**STAFF REPORT: APPEAL - DE NOVO HEARING**

APPEAL NUMBER: A-5-VEN-10-138

PROJECT LOCATION: 1305 Abbot Kinney Boulevard, Venice, City of Los Angeles, Los Angeles County.

PROJECT DESCRIPTION: Demolition of a one-story 1,312 square foot residential building, and construction of a 25-foot high, 1,248 square foot restaurant with a rooftop parking deck.

Roof-Parking Plan

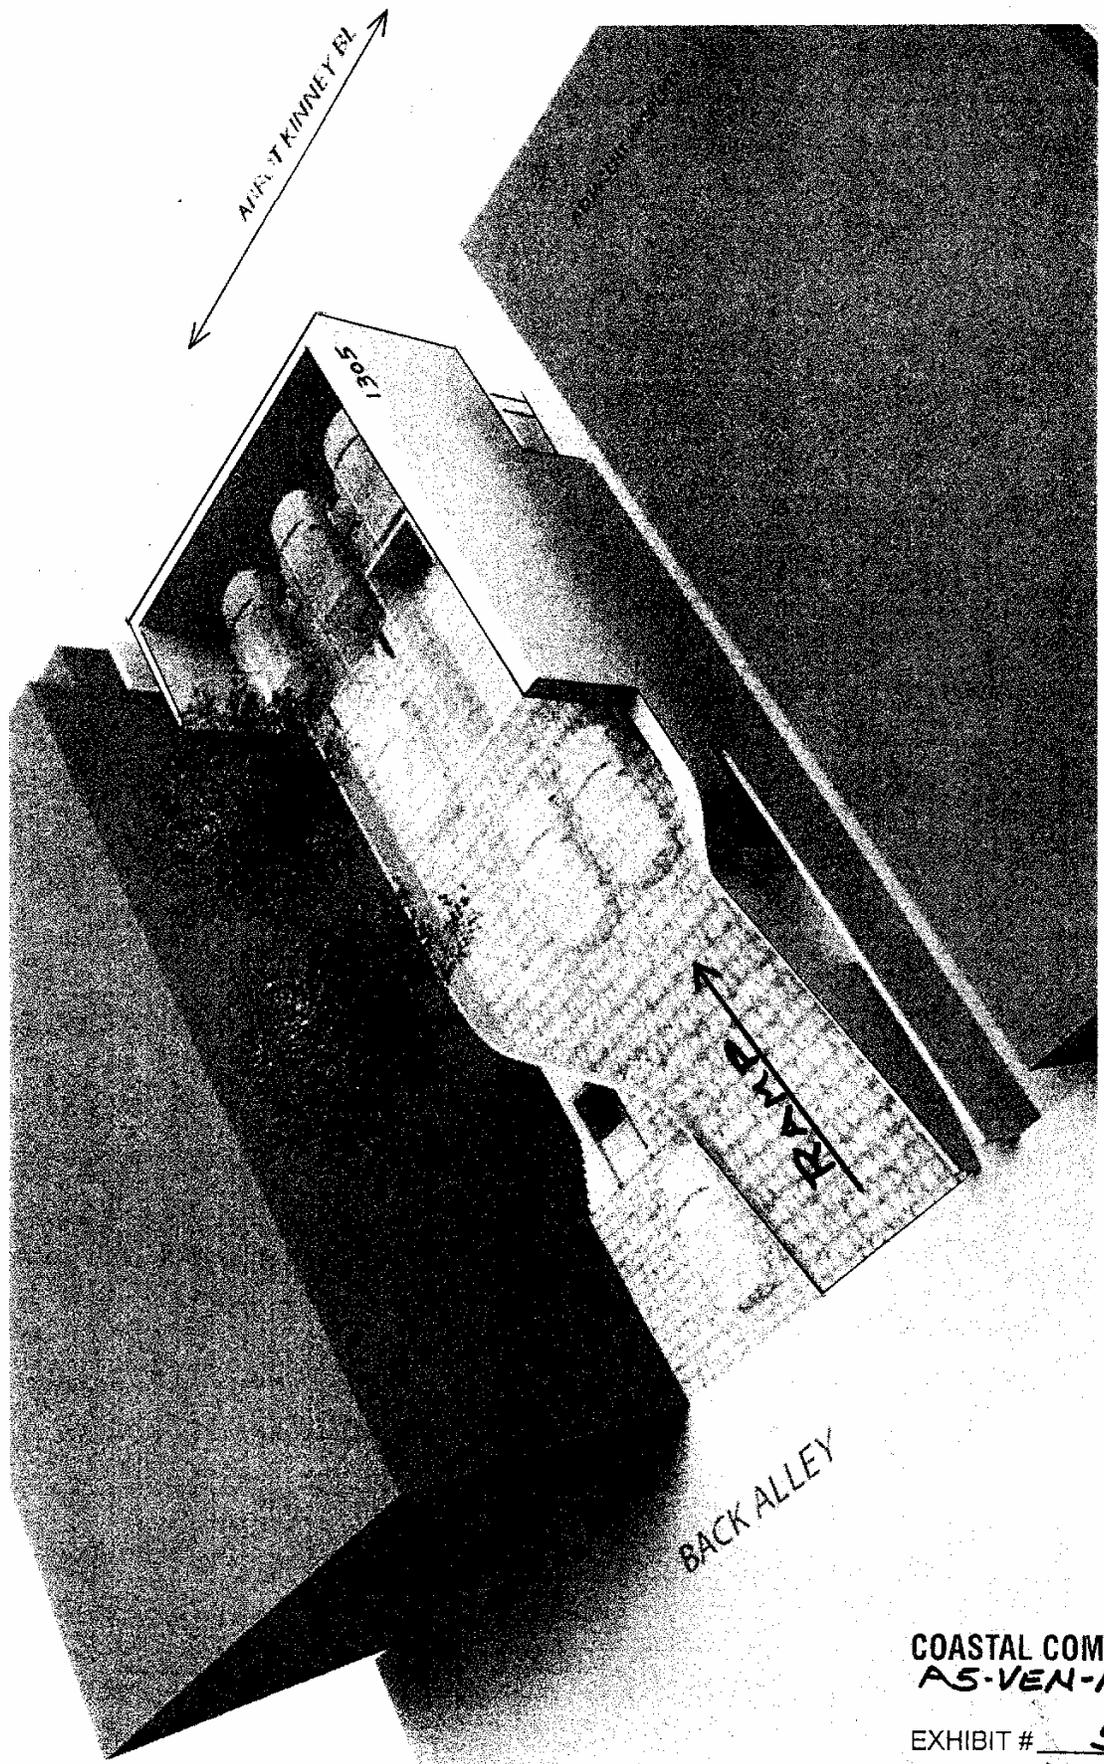
A. The Rooftop Parking Plan Has No Chance of Approval by the City.

The ramp portrayed in the Rooftop Parking Plan violates the City's code in so many obvious respects that it has no chance whatsoever of being approved by the City.

Second, the ramp is at least 2.5 times as steep as the maximum slope allowed under the City's zoning code. The plan shows a ramp rising to the top of the parking deck in a distance of just 24 feet. Assuming that the roof is just 12 feet high (and it would very likely be higher than that, given that restaurants typically have high ceilings), in order to get up to the roof, the ramp must rise at a 50% slope (i.e., at a 22.5 degree angle). The code maximum is a 20% slope, or 9 degrees.

Third, the proposed ramp goes from a flat alley to a flat parking deck, and does not show a "transition slope," as required by the City's code for all ramps steeper than 12.5%. The transition slope must 8 feet long and at both ends of the primary slope. It must be ½ the maximum slope (e.g., 10% for a 20% slope). The parking spaces themselves cannot be located on any slope greater than 5%, so they cannot be on the transitional slope.

Given the above constrains, even at the City's maximum 20% allowable grade, in order to climb to the top of a 12-foot roof the ramp would have to stretch 68 feet in length (i.e., 52 feet at 20%, plus two 8-foot transitional slopes at 10% each). Given that the lot is only 85 feet in length, the ramp would eliminate virtually all of the parking shown on the plan.

B. The Rooftop Plan Does Not Create Maneuvering Room On-Site.

The rooftop parking plan does not cure the problem that has existed with every other plan the applicant has proposed – namely, that there is no room on-site for maneuvering cars. This forces these activities to take place in the public alley, which is shared by other uses and parking, and is just 20 feet wide.

It should be emphasized that on the plan, the flat portion of the roof is completely consumed by triple-tandem parking. Meanwhile, the space behind the parked cars is entirely consumed by a steep ramp. This ramp is too narrow for a car to turn around, and given its steep slope any such maneuver would be extraordinarily difficult.

E. The Revised Plan Cannot Be Handled by Just Three Parking Attendants.

The Revised Project Description indicates that "One to three attendants would be on duty at any given time, depending upon parking demand." Yet, even three attendants would be far too few for this operation, because it only allows one tandem row to be unloaded at a time.

The proposed plan depicts three rows of triple-tandem parking, with two-level parking lifts at the rear. Even assuming that the upper levels of the parking lifts were used to store longer-term parked cars (such as employees), these cars would nonetheless move from time to time. Moreover, even when the lifts were not being operated, just unloading one of the tandem rows to retrieve the rearmost car would require three attendants – one to move the car to be retrieved, and two more to move the other cars out of its way.
